STATE BOARD OF HEALTH

OFFICE MEMORANDUM

TO: File-Cary Land Development
Landfill, Lake County

SUBJECT: Geologic Description and Evaluation

Logs (water wells)

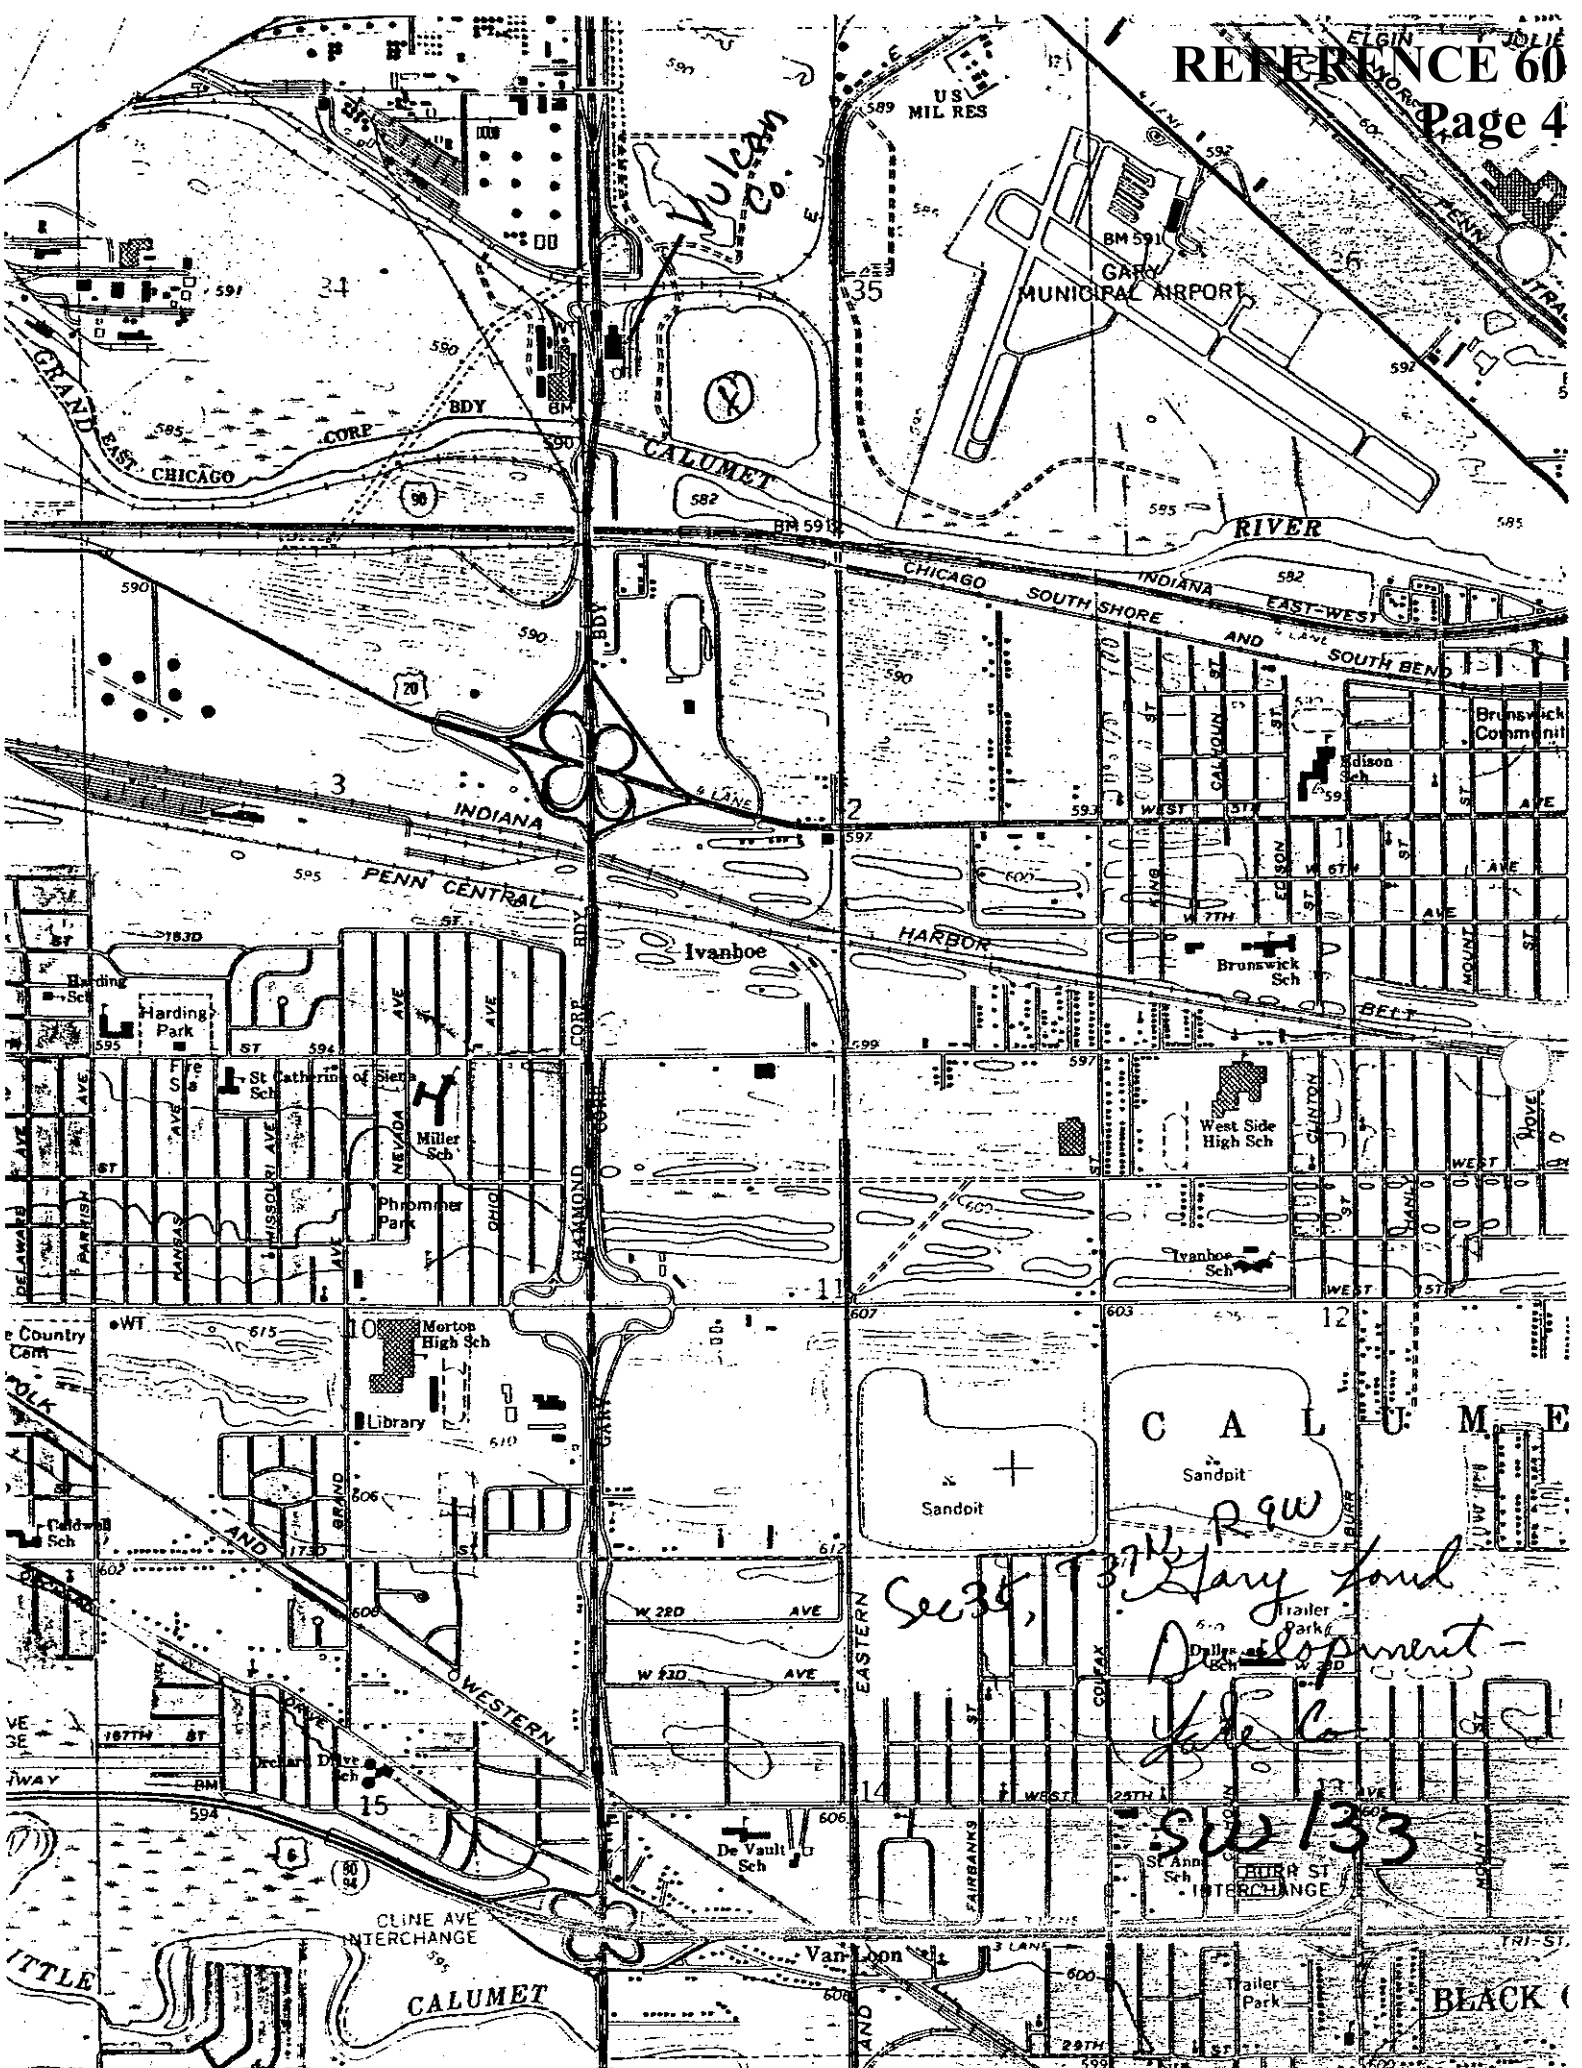
$$GW \text{ vel} \approx 57 \text{ ft./dy} \quad (i \approx \frac{1}{2})$$

i = nearly horiz. close to River, little influence on flow rate
 $2'/\text{mi.} = 0.00037$ (approximation of i , probably greater)

$$GW \text{ vel} \approx 0.021 \text{ ft./dy} \quad (i = 2'/\text{mi.}) \approx 7.7'/\text{yr.}$$

Well locations

(See W-Q data)
